SEWAGE DISPOSAL SYSTEM

DEPARTMENT OF HEALTH AND MENTAL HYGIENE

P 50790I
A REPAIR

SUBDIVISION _____ LOT _____ ROAD 3404 Sharp Road

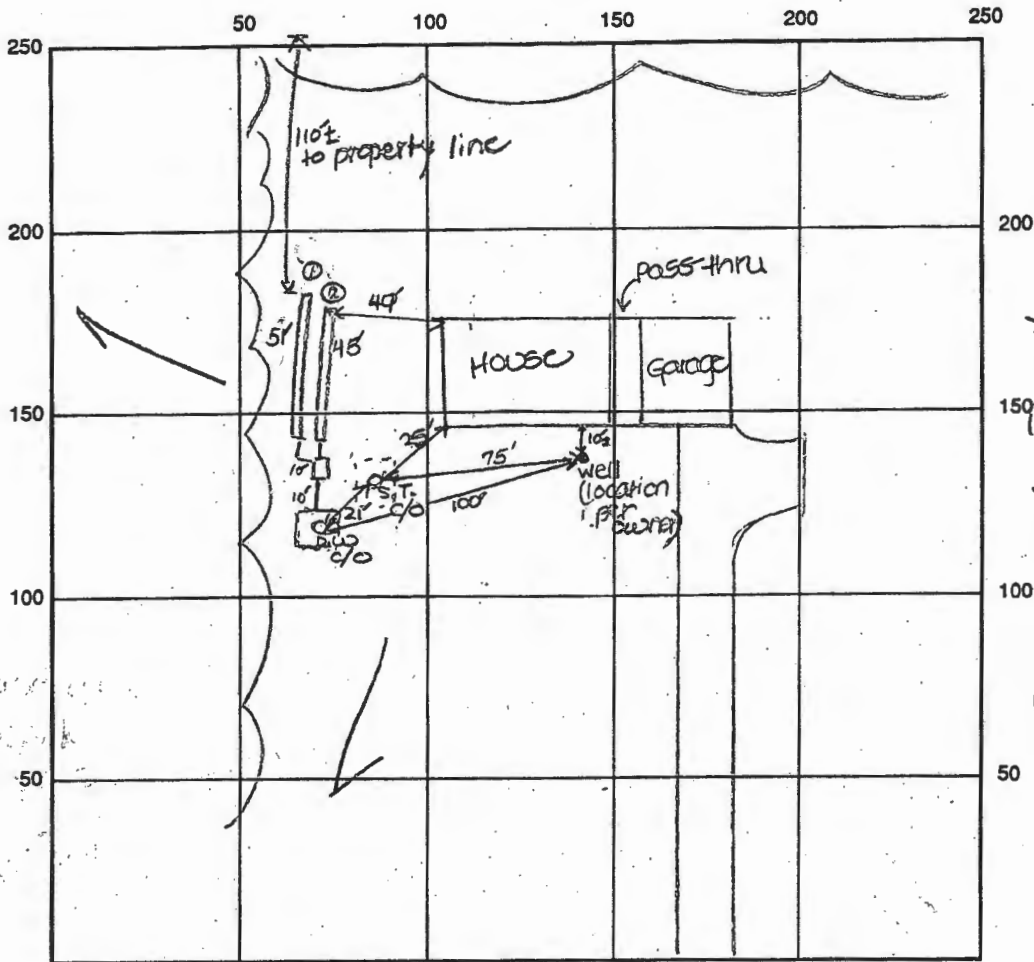
SEPTIC TANK LEVEL Existing CLEANOUTS are on st., one on d.w.

DISTRIBUTION BOX LEVEL OK - baffle in

DRAIN FIELD/TITLE DEPTH 10/10 FT. TRENCH WIDTH 2 FT. INLET DEPTH 4/5 FT.

EFFECTIVE GRAVEL DEPTH 6 FT. TOTAL LENGTH (11 51') (2 45) FT. → 96' total

NUMBER OF TRENCHES 2 ONE SIDEWALL/BOTTOM AREA 576 SQ. FT.

REMARKS: 7/11/95 A.M. OK to begin trenches and continue. DKS

7/11/95 P.M. Final - OK to cover all work. DKS

*Well casing not visible - location per previous drawing. DKS
